UNITED STATES PATENT AND TRADEMARK OFFICE

Office Action Summary	Application No. 10/823,468	Applicant(s) ALTMAN, SANFORD D.	
	Examiner LESLIE R. DEAK	Art Unit 3761

DETAILED ACTION

1: Uthmann FIG 1, annotated by Examiner

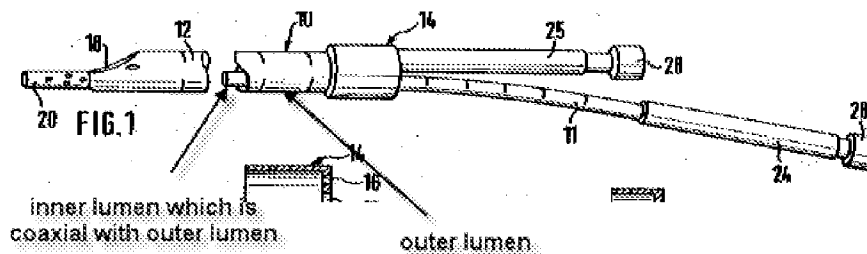
With regard to claim 1, Uthmann discloses a dual-lumen catheter with a first arterial, interior catheter 11 with distal end 20, a second, venous, outer catheter 12, both of which are attached to a hollow hub or cap 14 (see FIG 1 and accompanying text). The two lumens are coaxial along their entire length to hub or cap 14. (Applicant

illustrates that FIGS 1A and 1B of the instant specification illustrate a coaxial configuration. In FIG 1B, the inner catheter is offset from the center of the outer catheter. Since the catheters still share some of the same axis, this configuration is interpreted by the Examiner to encompass the coaxial configuration claimed by Applicant. Furthermore, Applicant illustrates that the lumens are coaxial to the hub 40 in FIG 2B. Accordingly, it is the position of the Examiner that the lumens disclosed by Uthmann are coaxial along the entire length as illustrated by Applicant.) The arterial lumen's distal tip 20 may extend beyond the distal end of venous catheter 12 (see FIG 1). Both lumens are slideable within the cap 14 and may be removed without altering the structure of either tube (see column 2, lines 48-67). Uthmann discloses that both the venous and arterial lumens have a plurality of distal openings. However, it has been held that the omission of an element (such as an opening) and its function is obvious if the function of the removed element is not desired. See MPEP § 2144.04(II)(A). Since Applicant does not desire the function of multiple holes, it would have been obvious to one having ordinary skill in the art at the time of invention to eliminate the undesired holes from the apparatus disclosed by the cited prior art.

With regard to claim 11, Uthmann illustrates that the inner catheter 11 lays against the wall of outer catheter 12, creating a circle-c configuration (see FIG 1).

2: Applicant's FIG 1B, annotated by Examiner

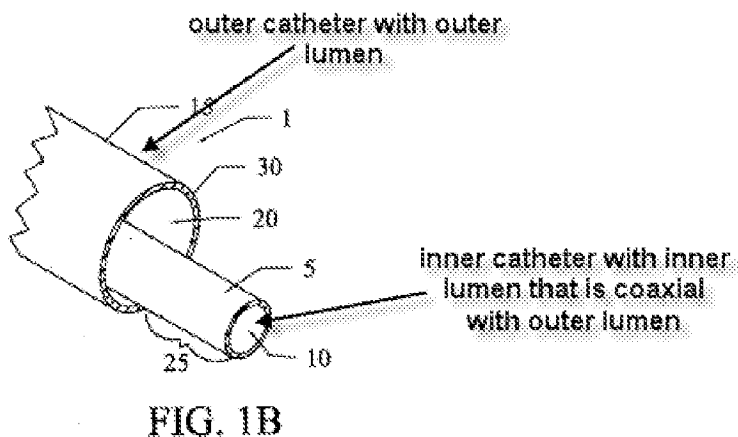
9. Applicant argues that Zawacki teaches two, distinct, separate, non-coaxially situated catheter tips. The Examiner respectfully disagrees. Applicant discloses that FIG 1B of the instant drawing comprises a coaxial configuration, in which the inner catheter is situated eccentric to the outer catheter. The Zawacki catheters, as shown in FIGS 1-6, comprise the same general configuration, in which inner catheter 30 sits inside and eccentric to outer catheter 20. Accordingly, it is the position of the Examiner that the cited prior art suggests a coaxial catheter arrangement that fits the description provided by Applicant.
